January 18, 2002
LIC-02-0009

**SUBJECT: Fort Calhoun Station Unit 1
Revised Application for Renewed Operating License**

**Restored and Corrected Pages for Appendix E of the
Fort Calhoun Station Unit 1 Application for Renewed Operating License**

**FIGURE 2.4-2
BLACK MINORITY POPULATION
WITHIN 50 MILES OF FORT CALHOUN
STATION UNIT 1**

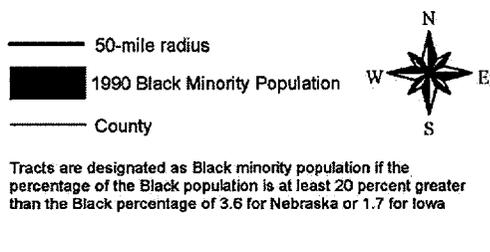
- (1) Restored Figure 2.4-2, page 2-35
- (2) The last 12 pages of Appendix 2, *Clean Water Act Documentation*, incorrectly numbered as pages 2-31 through 2-42, now numbered as pages 2-42 through 2-53.
